ECE/TRANS/WP.29/GRE/2008/57
17 July 2008

REGULATION No. 48

Interpretation of paragraph 5.7. of the Regulation

Proposal for Supplement 3 to the 04 series of amendments to Regulation No. 48

a) Examples of arrangements that shall not be allowed

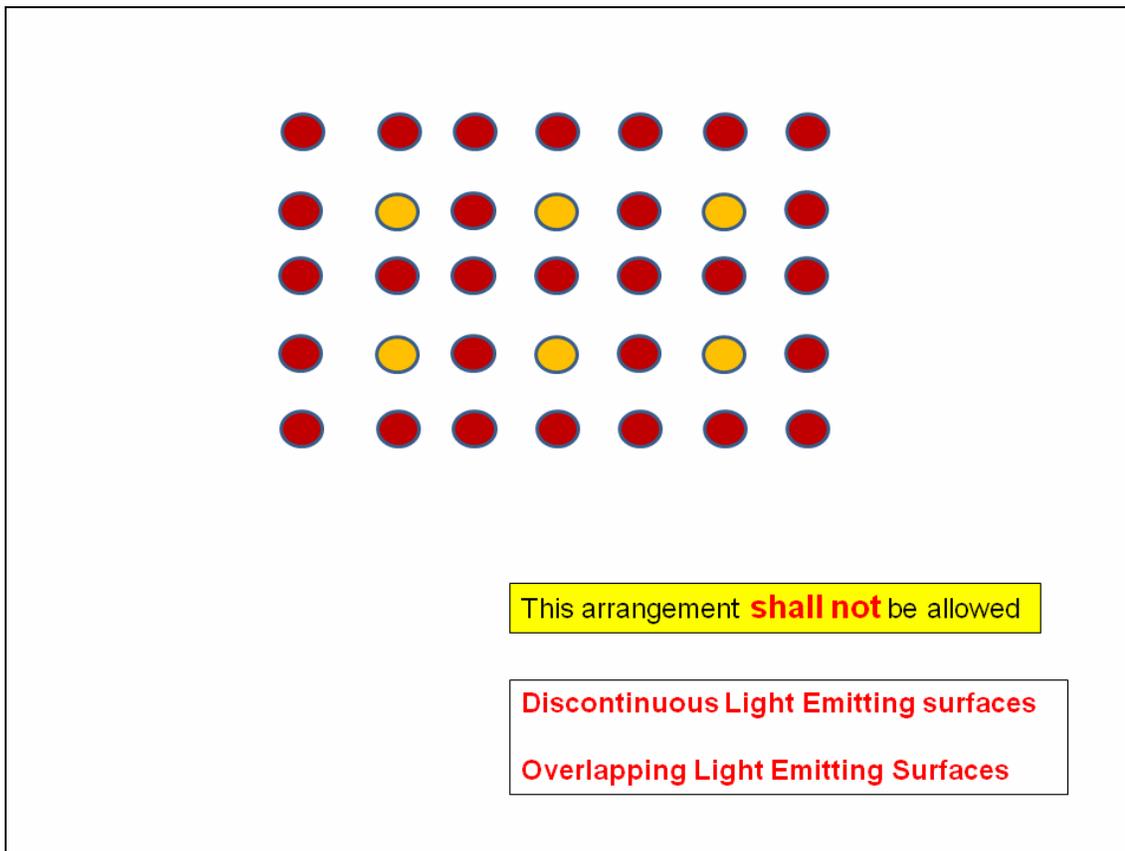
During its fifty-ninth session, GRE adopted GRE-59-09 tabled by the expert from Japan relating to the reciprocal incorporation of stop lamps and direction indicators. Having now fully studied the adopted change to paragraph 5.7.1. in conjunction with the definitions of "reciprocally incorporated", "illuminating surface" and "light emitting surface", it has been found that many arrangements of direction indicator and stop-lamps that are proven to be operating satisfactorily in service will be not allowed when the amendment will enter into force.

The amendments in this proposal are intended to clearly indicate the conditions when stop lamps and direction indicator lamps shall, or shall not be, considered to be "reciprocally incorporated" and to clarify the associated definitions.

In developing this proposal, care has been taken to ensure that the essence of the proposal by the expert from Japan is maintained. Additionally, account has been taken of the serious concerns expressed in published reports concerning the problem of overlapping functions and the issue that overlapping illuminating surfaces of functions of similar intensity result in significant delay in perception.

Here below some examples of arrangements are provided to show what shall not, and shall be allowed by the amendments proposed.

- "5.7.1.2. Stop lamps and direction indicator lamps are not permitted to be reciprocally incorporated.

5.7.1.3. Where stop lamps and direction indicator lamps are grouped, **the following conditions shall be met:**

5.7.1.3.1. any horizontal or vertical straight line passing through the projections of the apparent surfaces of these functions on a plane perpendicular to the reference axis, shall not intersect more than two borderlines separating adjacent areas of different colour;

5.7.1.3.2. **their apparent surfaces in the direction of the reference axis, based upon the areas bounded by the outline of their light emitting surfaces, are continuous and do not overlap.**
